Waste Management Facility, Botany

Integrated Water Management Strategy

Coombes Property Group Pty Ltd

1.2 RESPONSE TO SUBMISSIONS COMMENTS

Figure 5. MUSIC Model Treatment Train and Results

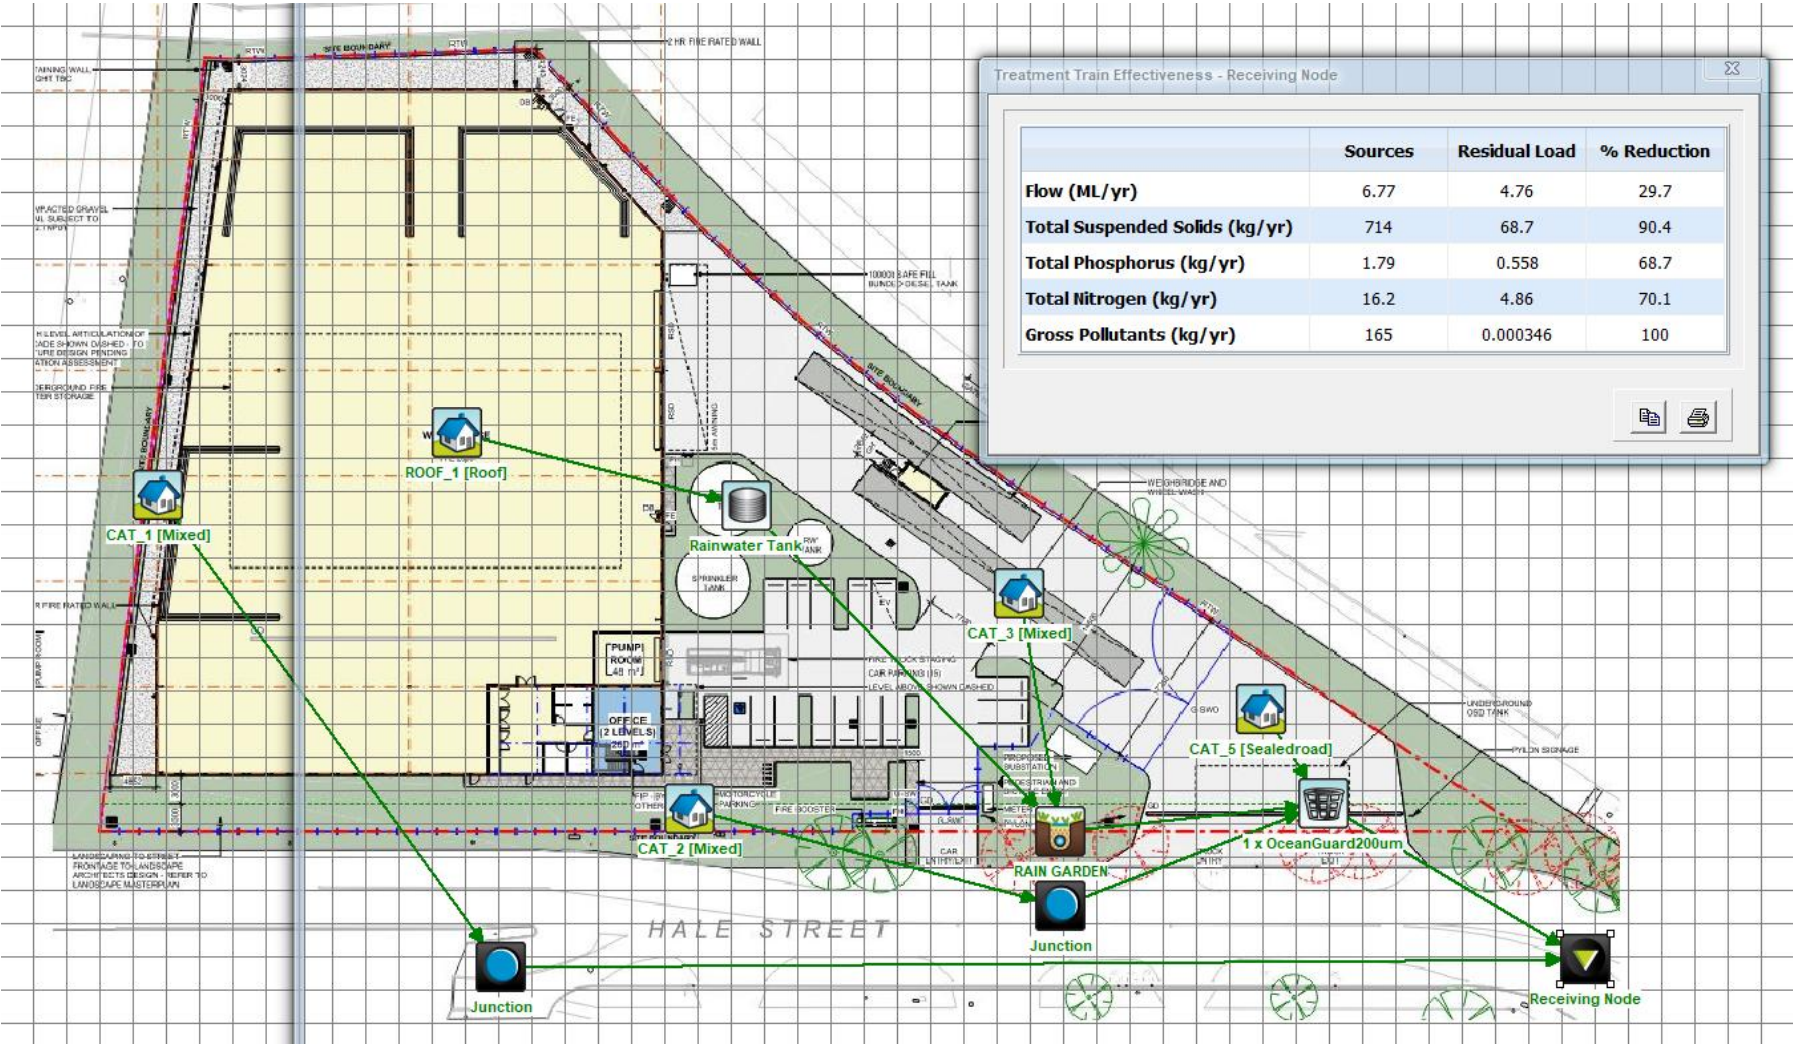
<p>Furthermore, figure 5 of this report cannot be assessed as it does not include the areas of each catchment and is not supplemented by stormwater plans verifying the catchment areas and demonstrating the treatment train is feasible.</p>	<p>Refer to Table 4 on Section 5.8 and Catchment area plan in Appendix C</p>	<p>Section 5.8: Table 3; Appendix C</p>
<p>The parameters of the bioretention system in the MUSIC model shall be shown. The bioretention system appears to be overperforming and it’s not clear how the site will effectively capture gross pollutants from impervious areas. Furthermore, it needs to be detailed how this system will work given the substation and trees proposed in this area.</p>	<p>This is included in the soft copy of the MUSIC file provided for council review.</p>	<p>Attached .sqz file</p>
<p>A soft copy of the amended MUSIC modelling shall be provided.</p>	<p>As above</p>	<p>Attached .sqz file</p>

RG.01
RAINGARDEN - TYPICAL SECTION
SCALE 1:25

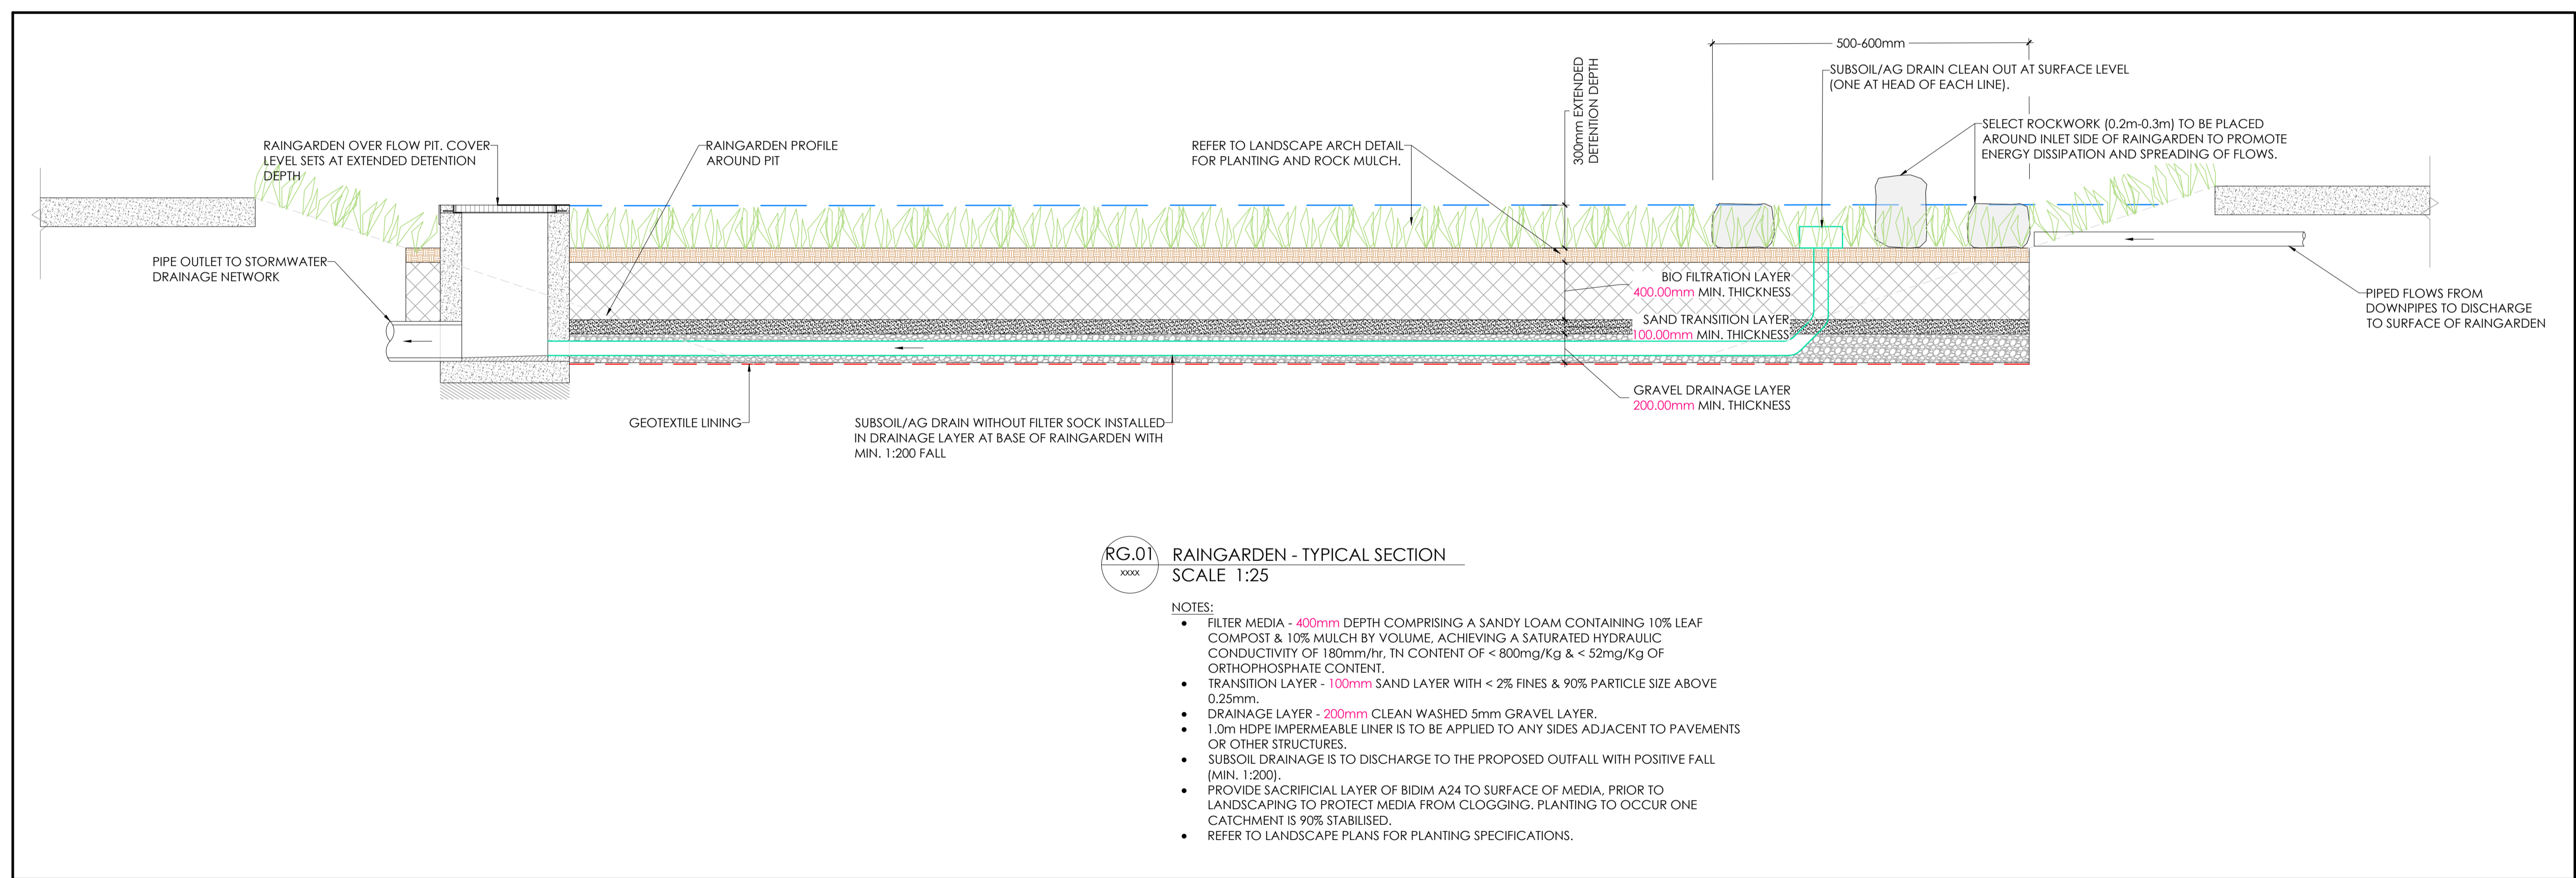
Bayside Council Comments	Proponent Response	Location Addressed
<p>j) The following issues have been identified in the plan submitted:</p> <p>i. No sections or design details of the raingarden have been provided for review. This is particularly important as the raingarden appears to be overperforming in its impact on water quality treatment.</p> <p>ii. Design levels and pipe/culvert sizes for the drainage systems were not sufficiently submitted.</p> <p>iii. Proposed pipe sizes are not confirmed.</p> <p>iv. Trapped low points are created in the northern corner of the site with no drainage provided</p> <p>v. Insufficient details have been provided for the drainage works in the road reserve that the development is relying on for discharge. The previous submission matter requiring additional survey data has not been addressed.</p> <p>vi. No manufacturer specifications for the Stormwater Quality Improvement Devices are provided in the drawings. Hence the MUSIC modelling cannot be confirmed.</p> <p>vii. No specifications of drainage elements such as pits including standard details are shown on the plans. "</p>	<p>i. Refer to dwg C-8001 showing details of raingarden.</p> <p>ii. Refer to dwg C-1100 for design levels, and dwg C-1110 and C6001 for drainage system</p> <p>iii. Refer to dwg C-1110 for pipe sizes</p> <p>iv. Refer to dwg C-1100 for design levels and falls. There will be no trapped low points created in the northern corner of the site.</p> <p>v. Refer to dwg C-1110 for drainage system. The updated survey drawing is attached in Appendix B.</p> <p>vi. Refer to dwg C-1110 drainage WSUD system. The OceanGuard 200micron GPT manufacturer is Ocean Protect.</p> <p>vii. Refer to dwg C-8000 for stormwater standard details</p>	<p>Appendix C – Civil Drawings as standalone package of plans, and also included in this report as appendix</p>
